# Proposed changes to London Luton Airport Arrivals

## SAIP AD6 Supplement:

Stansted Airport SID climb performance evidence  
supporting technical changes to altitude restrictions  
enabling the raising of CAS base levels

Figure 14 Rwy 04 DET1S and Rwy 22 DET1R, to DET2S and DET2R (conventional)

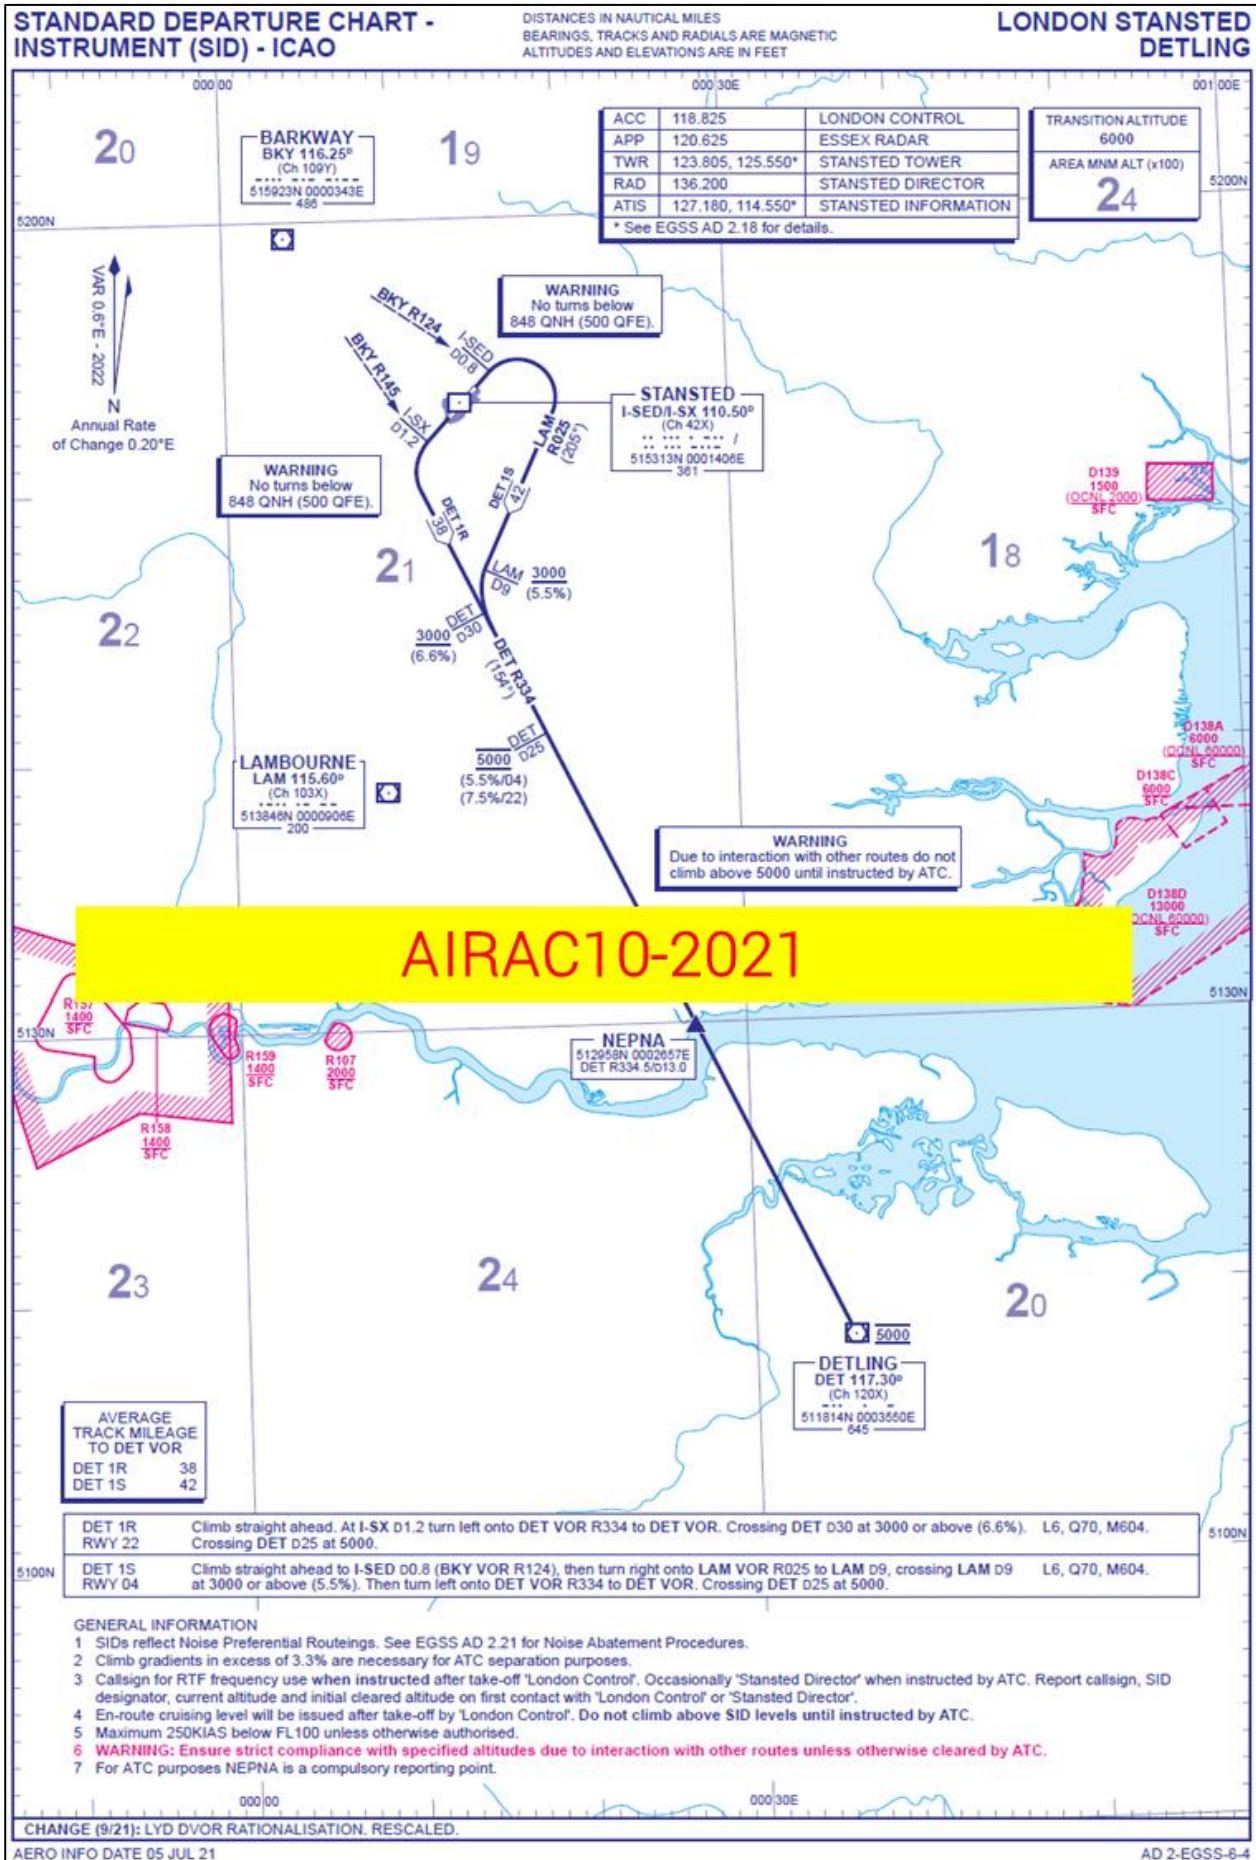
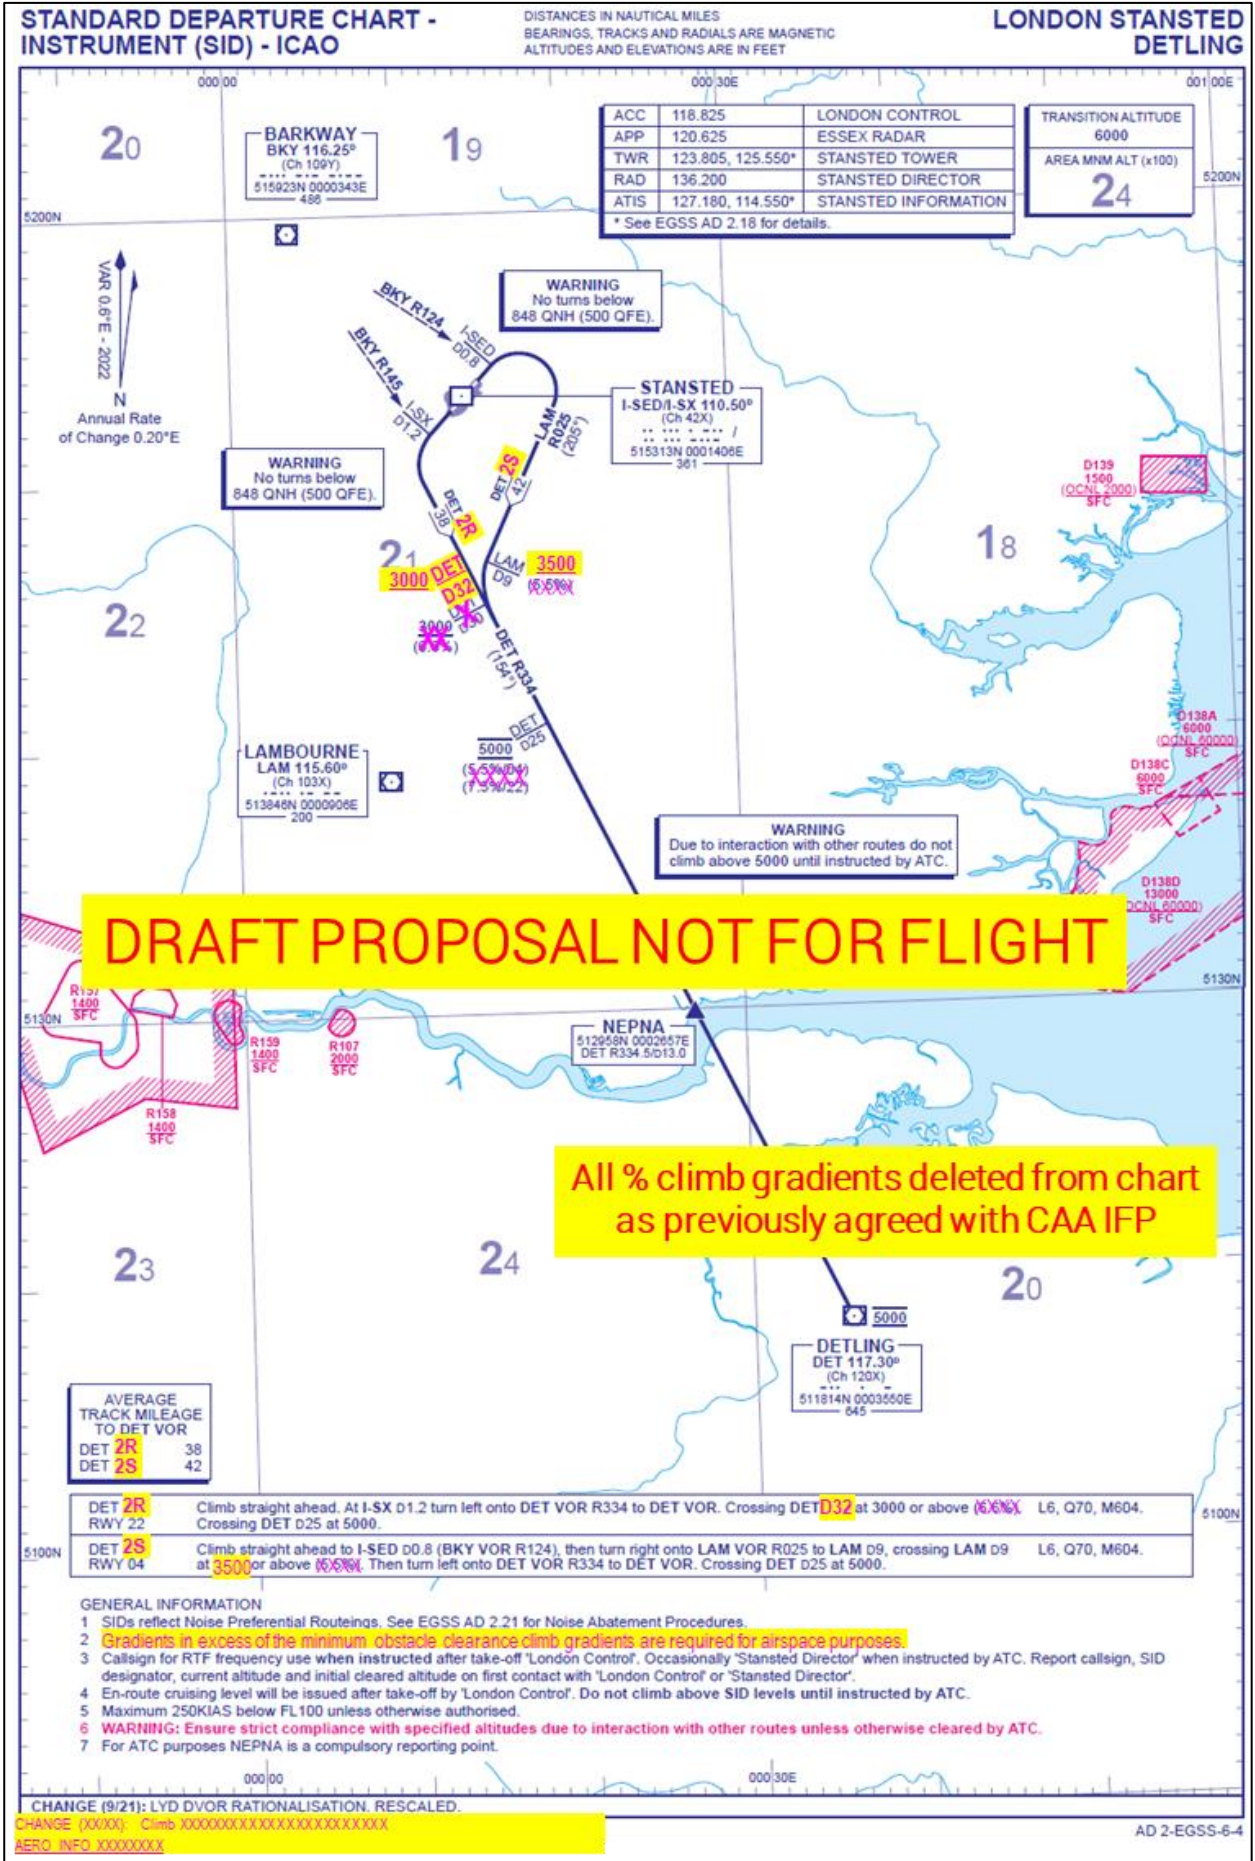
- 6.4.1 Change altitude restriction at LAM R025D09 from 3000ft to 3500ft.
  - 6.4.2 Up-issue the SID chart to DET2S (Figure 14 on p.25).
  - 6.4.3 As per the evidence supplied in paragraph 4.9 from p.14, aircraft already meet or exceed this proposed restriction.

- 6.6.1 Add an altitude restriction at DET R334D32 3000ft.
  - 6.6.2 Delete the altitude restriction at DET R334D30 3000ft

- 6.6.3 This has the effect of moving the 3000ft restriction 2nm closer to the runway along the same track.
- 6.6.4 Up-issue the SID chart to DET2R (Figure 14 on p.25).

Figure 16 Rwy 04 DET1D, to DET2D (RNP1) Chart

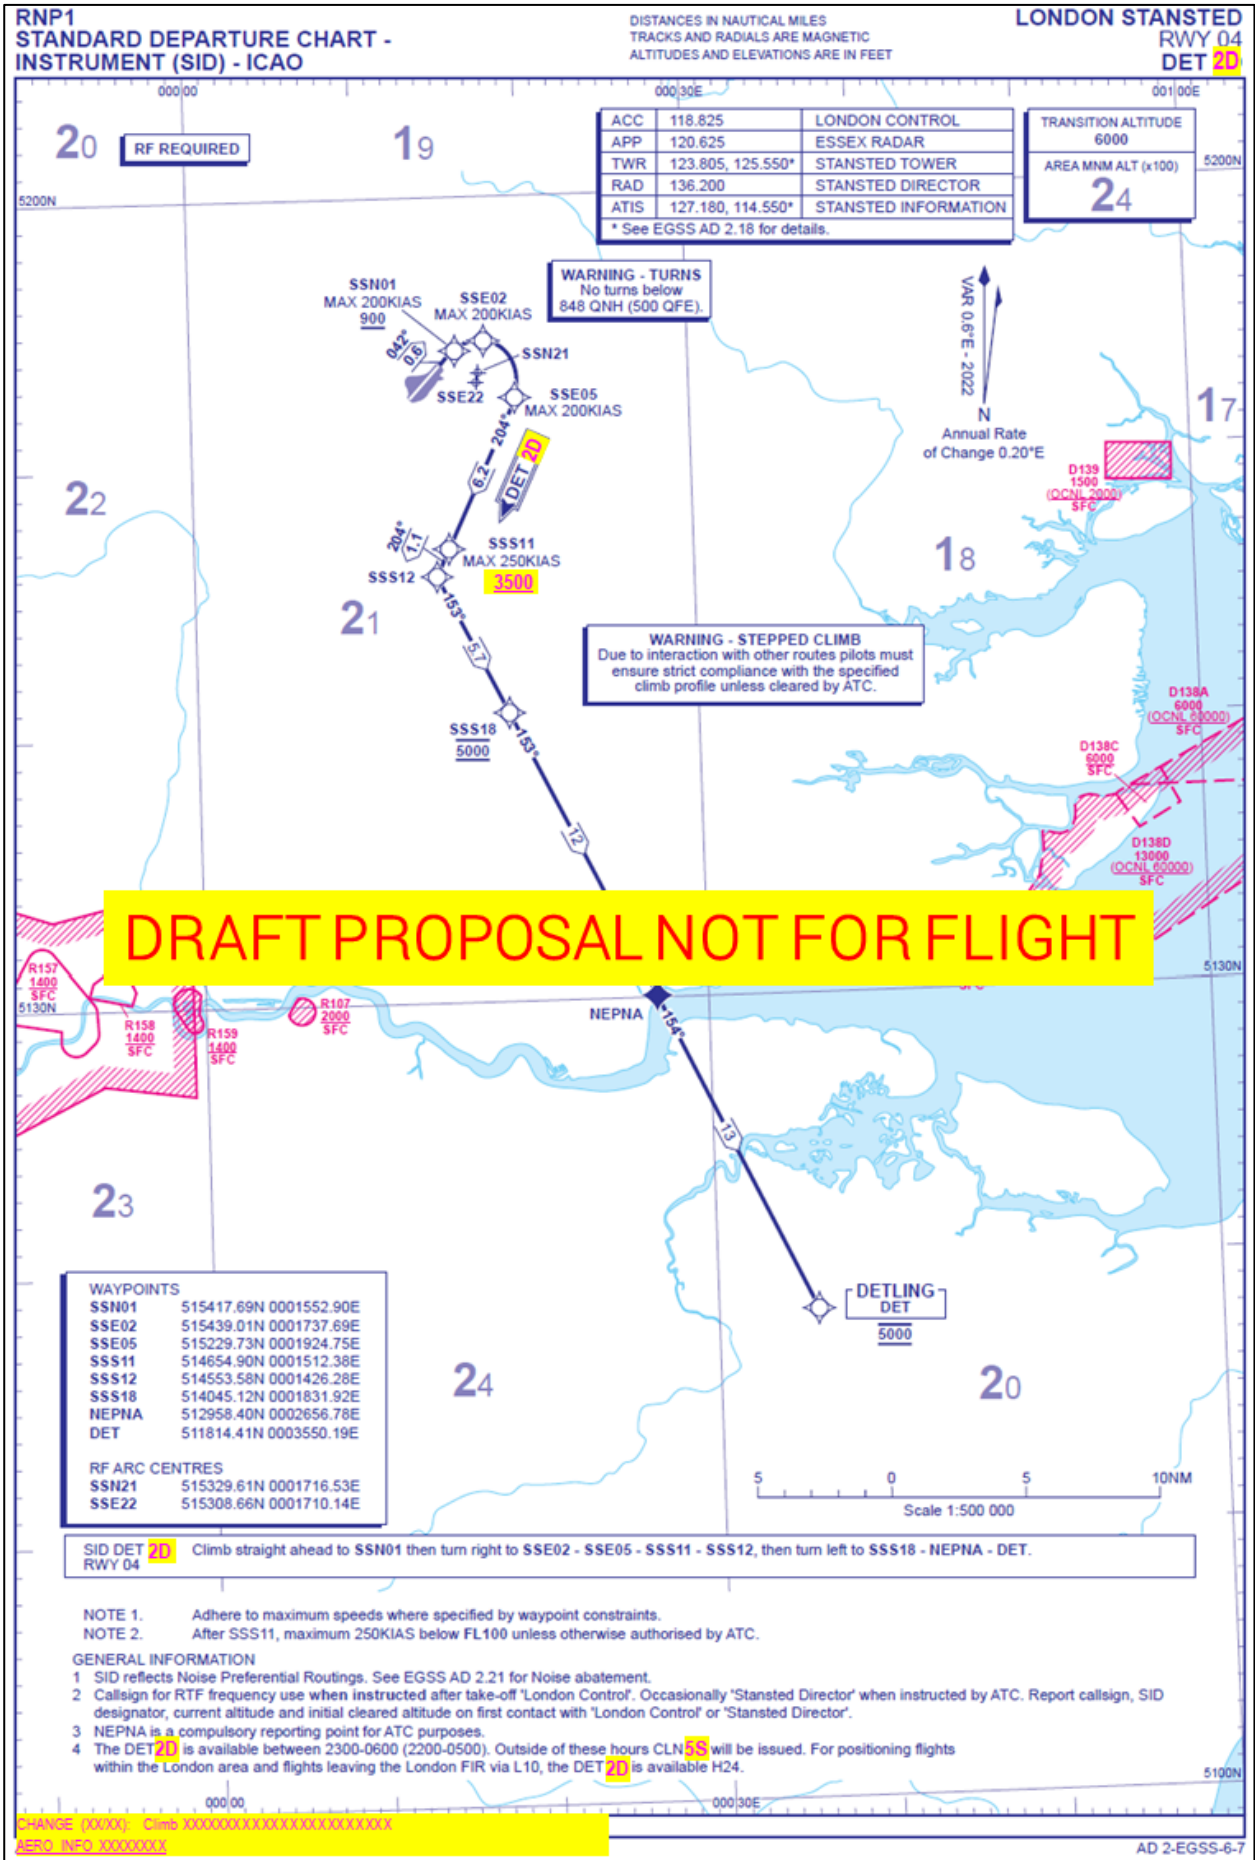
- 6.5 Rwy 04 DET1D (RNP1)
  - 6.5.1 Change altitude restriction at SSS11 from 3000ft to 3500ft
  - 6.5.2 Up-issue the SID chart and coding table to DET2D (Figure 16 on p.27 and Figure 20 on p.31).

Figure 18 Proposed Rwy 22 LAM3R and Rwy 04 LAM2S, to LAM4R and LAM3S (conventional)

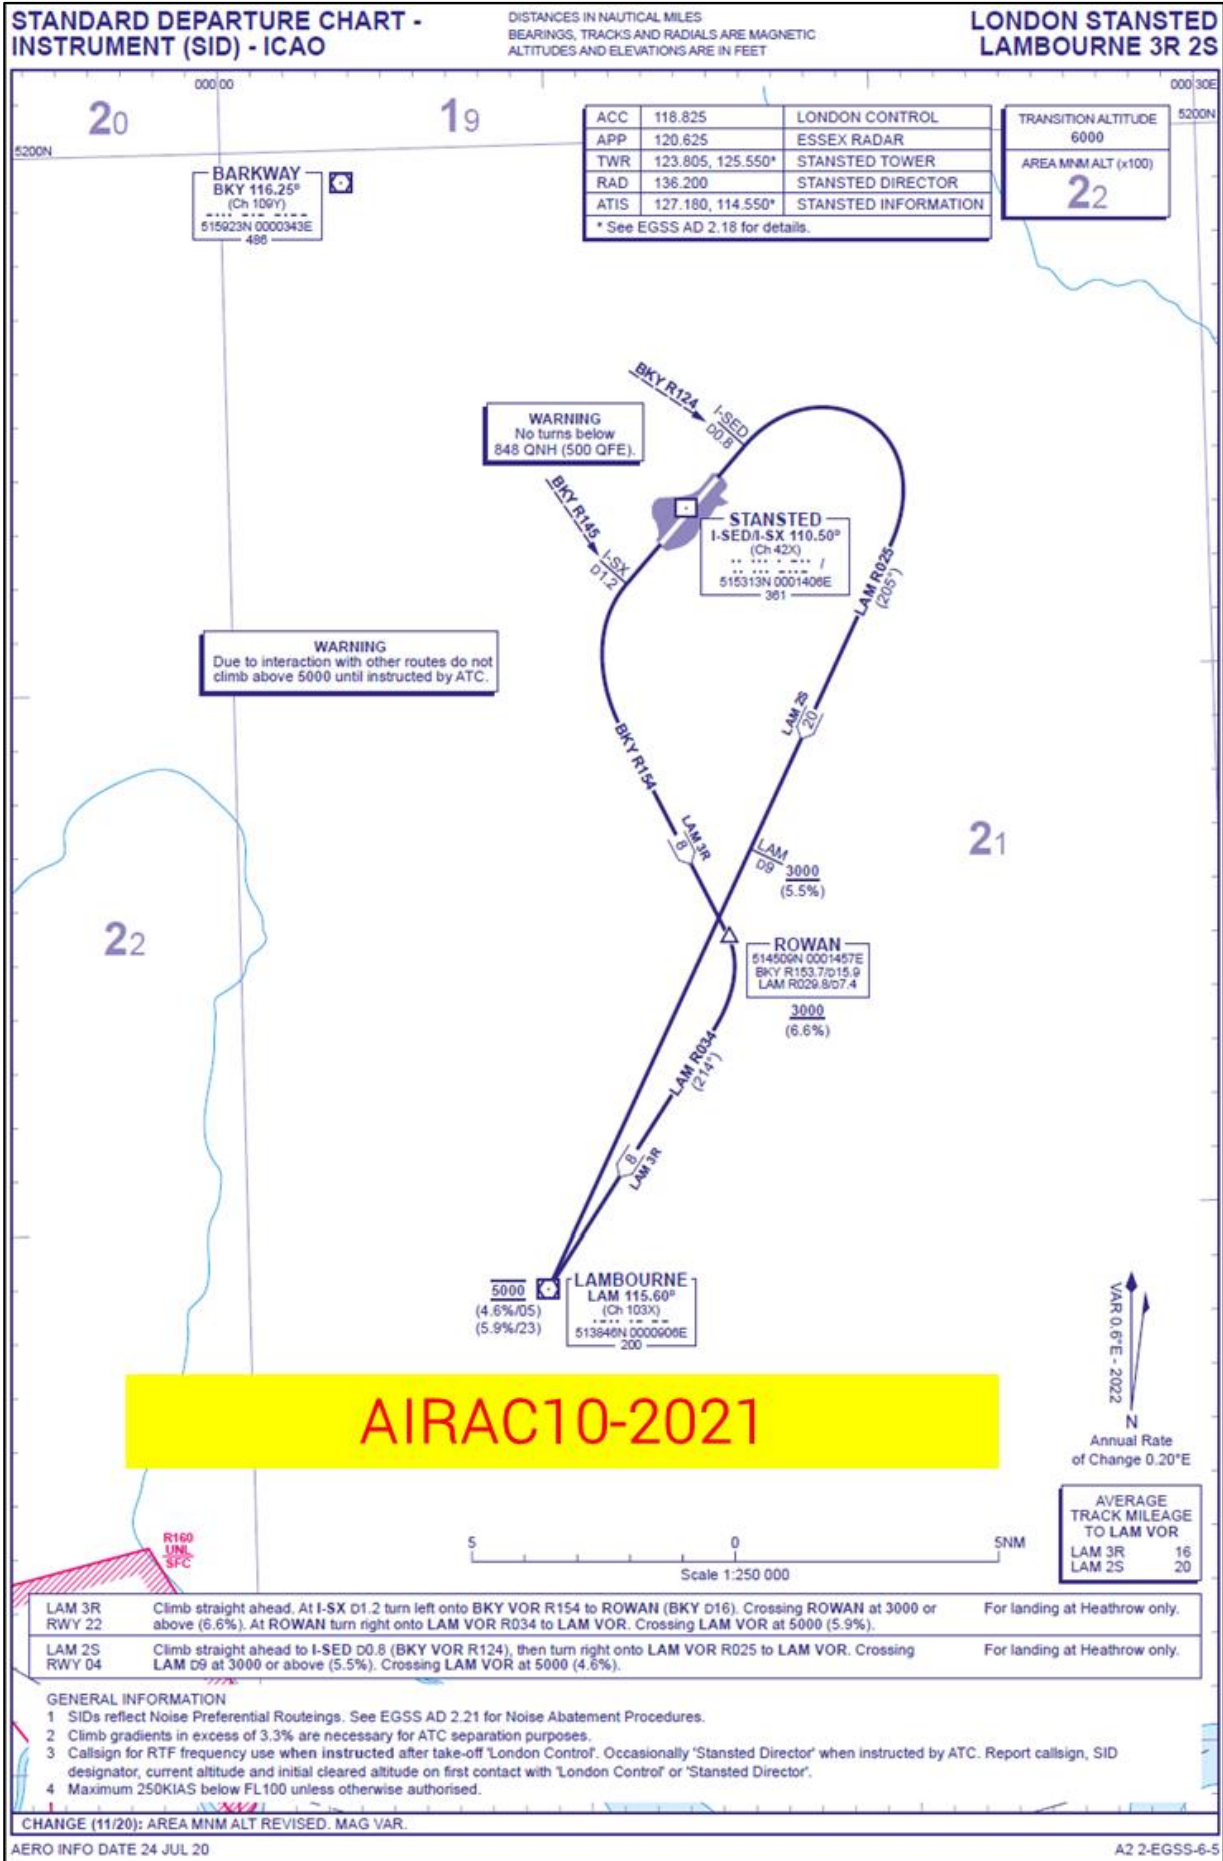
- 6.7.1 Change altitude restriction at LAM R025D09 from 3000ft to 3500ft
  - 6.7.2 Up-issue the SID chart and coding table to LAM3S (Figure 18 on p.29).

- 6.8.1 Add an altitude restriction at BKY R154D13.8 3000ft.
  - 6.8.2 Delete the altitude restriction at ROWAN (BKY R153.7D15.9) 3000ft
  - 6.8.3 This has the effect of moving the 3000ft restriction 2.1nm closer to the runway along the same track.

- 6.8.4 Up-issue the SID chart to LAM4R (Figure 18 on p.29).
  - 6.8.5 As per the evidence supplied in paragraph 4.8 from p.12, aircraft already meet or exceed this proposed restriction.
